31 FORE ST Additional Conditions

C. SITE PLAN REVIEW

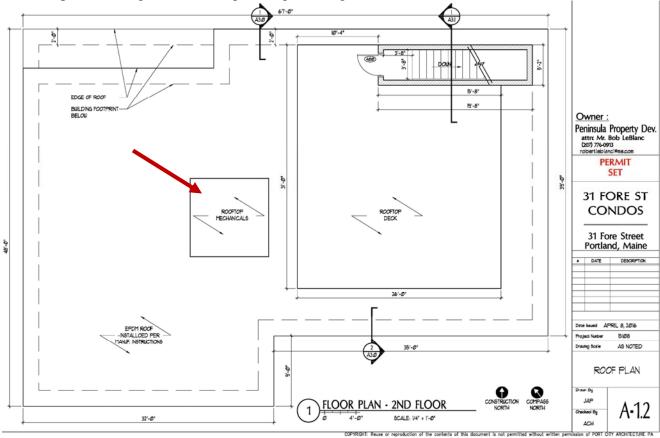
i. That the applicant shall confirm which entrance is the main entrance and revise this main entrance to meet the R6 Design standards as outlined in the Design Review comments, and to meet the Site Lighting Standards of the Technical Manual, with the revised proposals submitted to the Planning Authority for review and approval prior to the issuance of a building permit.

The main entrance is now on the Waterville St side of the building. The entrance is marked with an overhead canopy with down lights, PA system and Building signage. (See below for rendering)

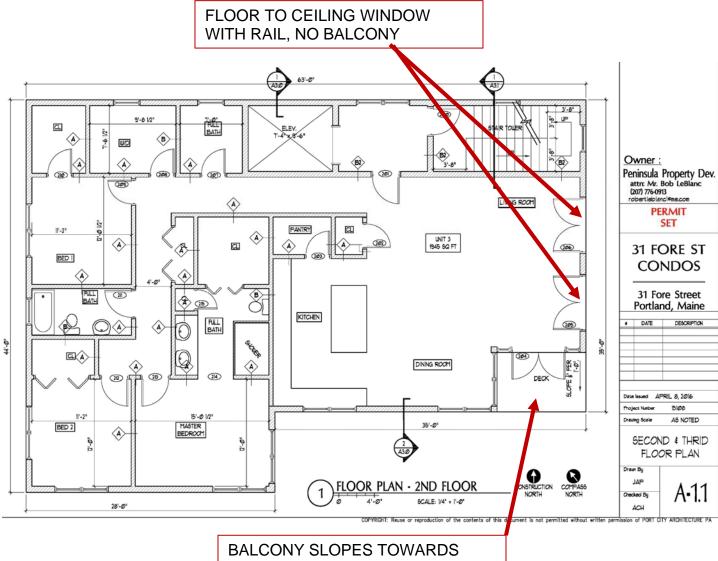
ii. That the applicant shall submit plans and associated information the clarify the location and sound levels of all external heating, ventilation and other mechanical equipment and document that they meet the City's Site Plan, Zoning and Technical Standards, for review and approval by the Planning Authority;

All Mechanical and HVAC systems are located in the center of the top roof to minimize sound and visual impacts on neighbors and neighboring buildings. (See below for Roof Plan)
